ISSUE DATE	08/01/03
DATE	REVISION
GAD DWG FILE: ADTAYLOR	
DRAWN BY: JCT	
CHECKED BY:	
SHEET TITLE	
Elevations	
1-A	
SHEET 1 of 3

**Garage Addition for**  
 Susan Taylor  
 35 St. George Street

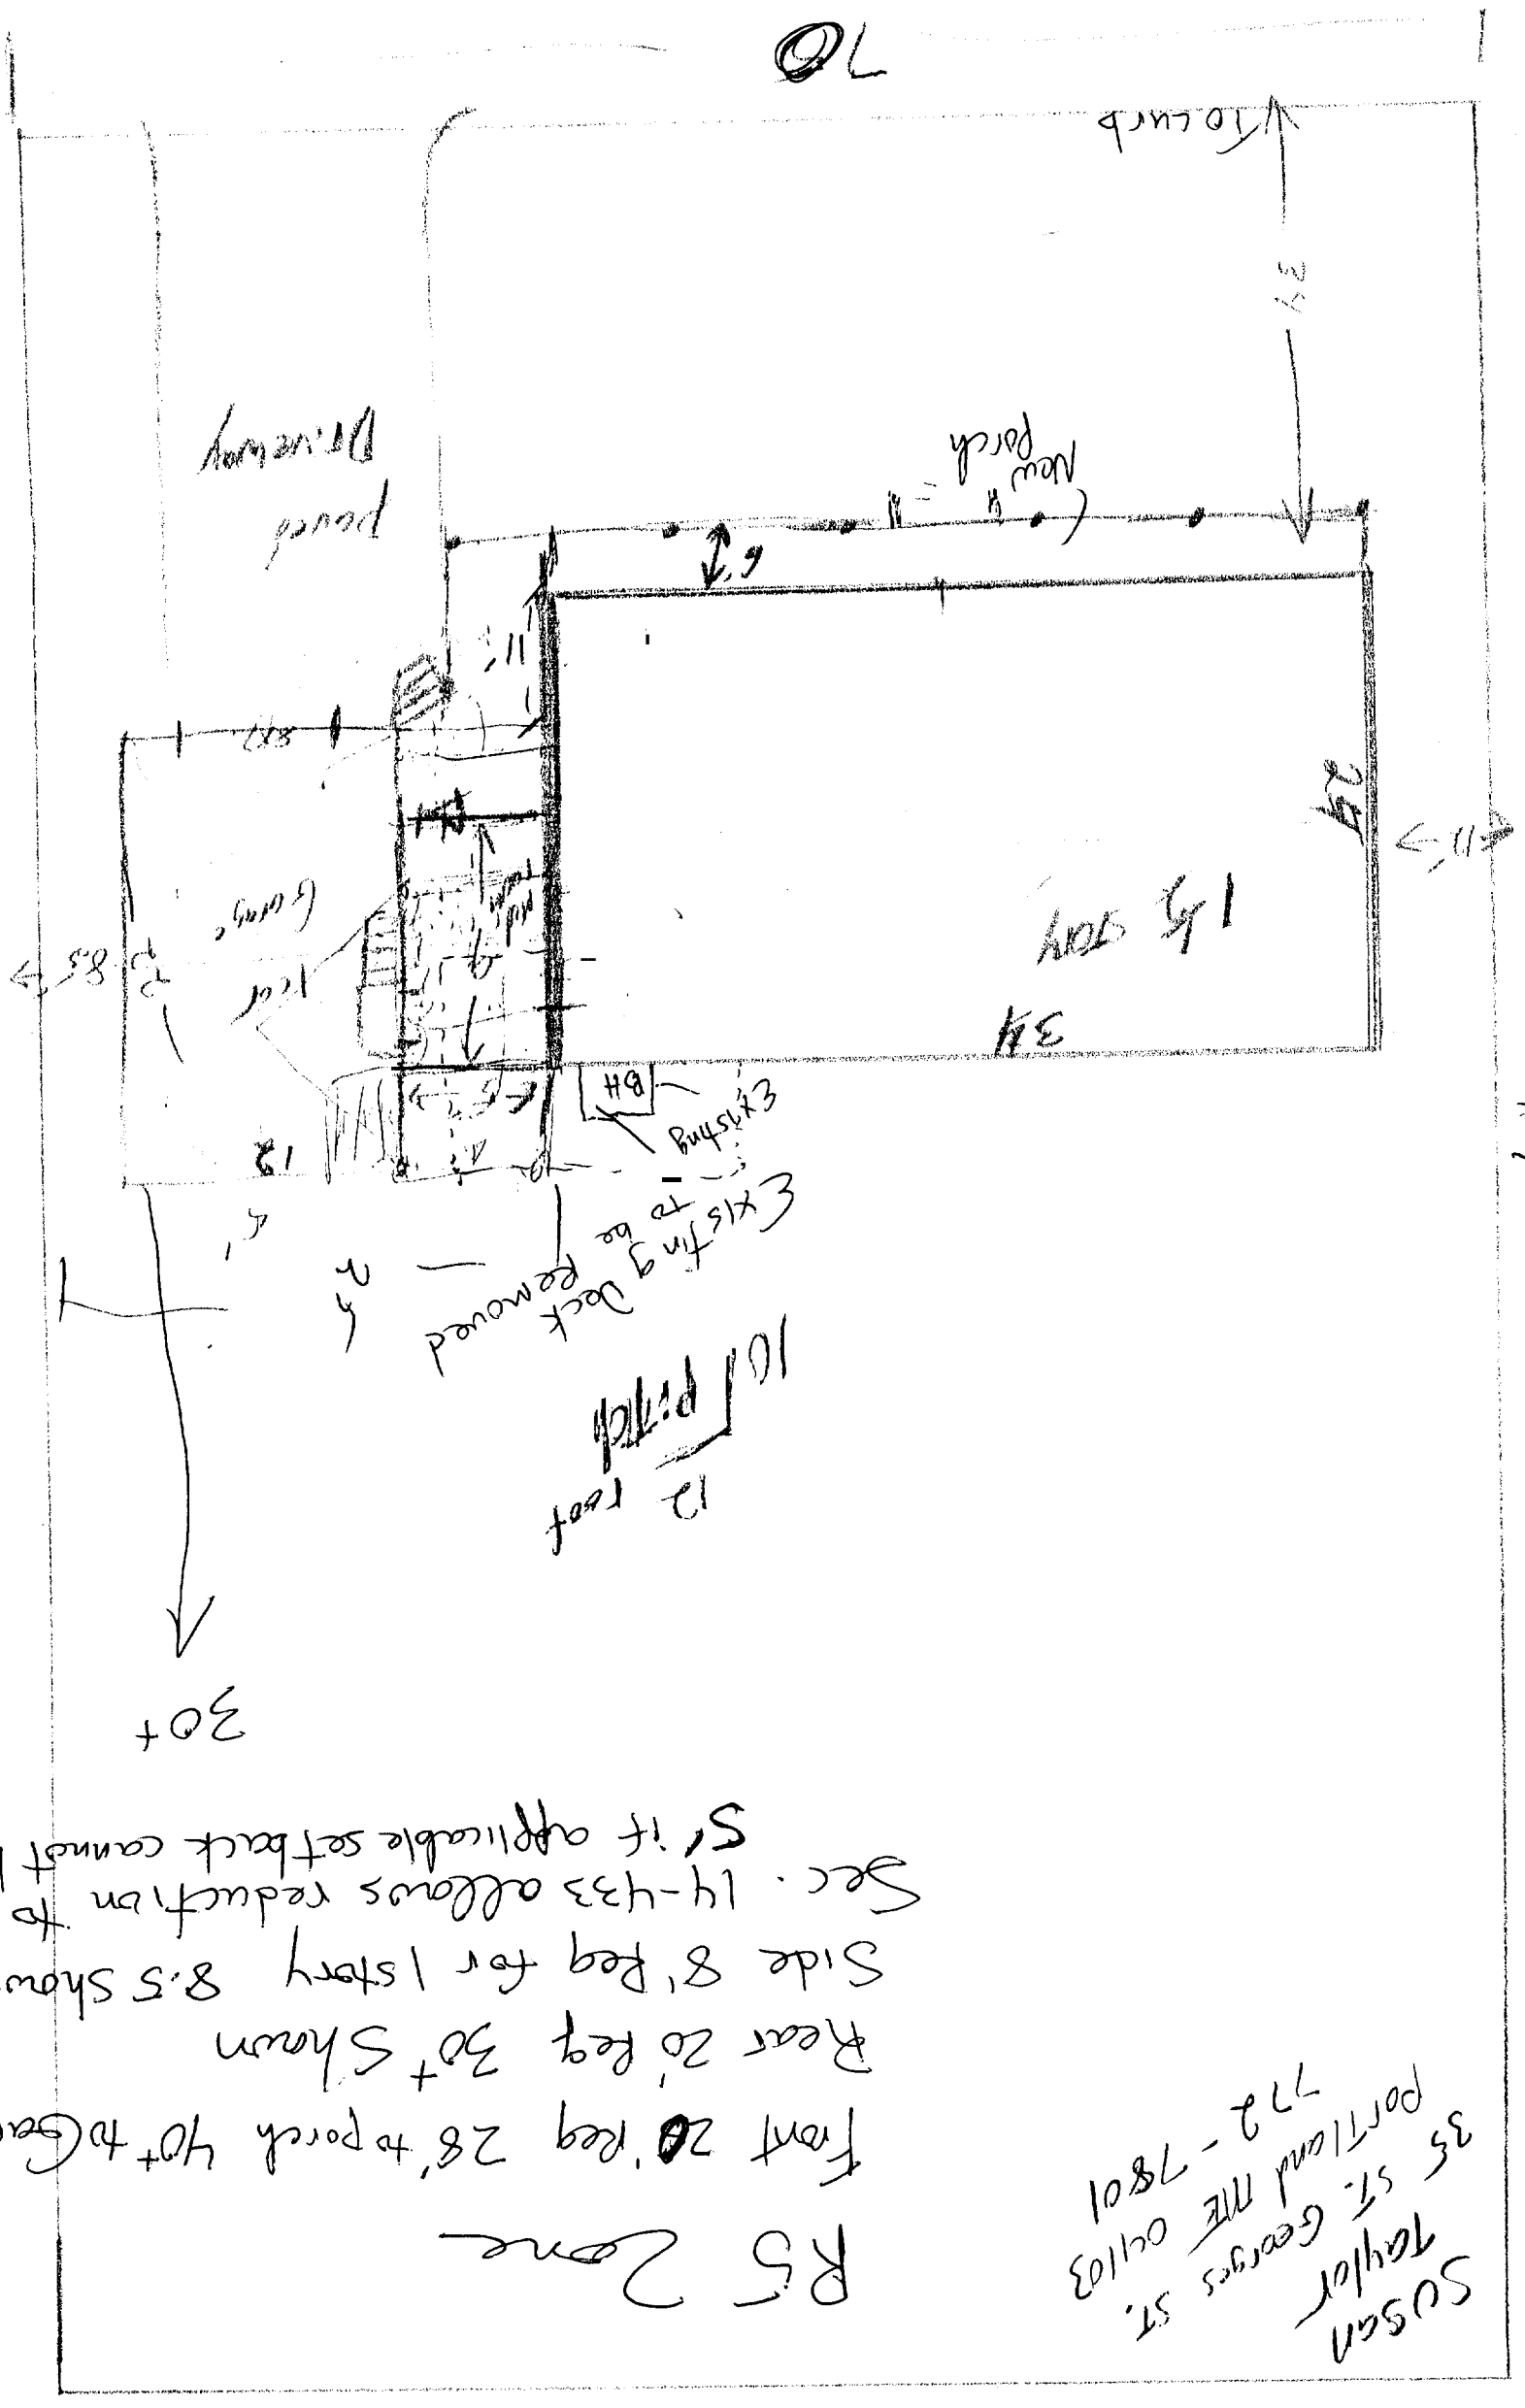
R5 Zone  
 Front 20' req 28' to porch 40' to Garage shown  
 Rear 20' req 30' shown  
 Side 8' req for 1 story 8.5 shown  
 Sec. 14-433 allows reduction to  
 S' if applicable setback cannot be met
